Drawn: Tom Hagen
19JUL2013

SuperSID Version 3, Rev. 3 Pre-Amplifier

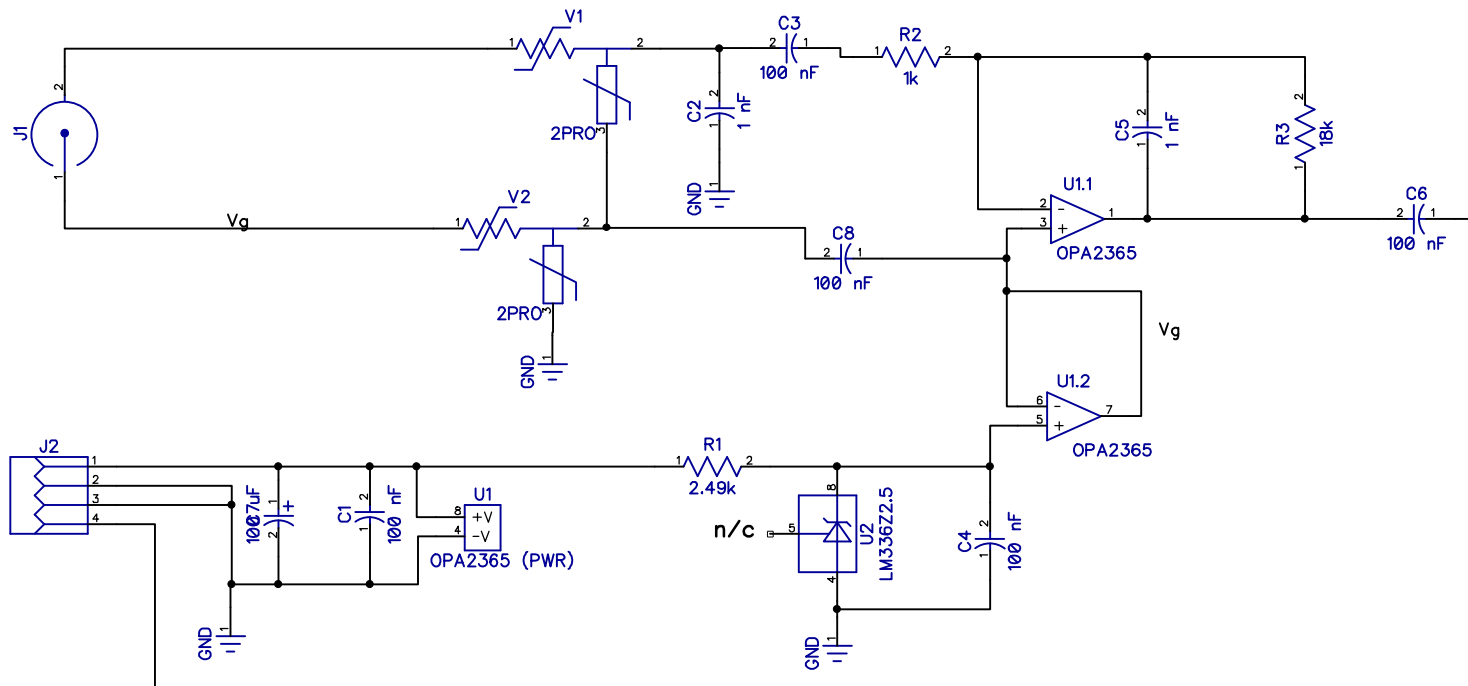
3 Change Loop input to BNC
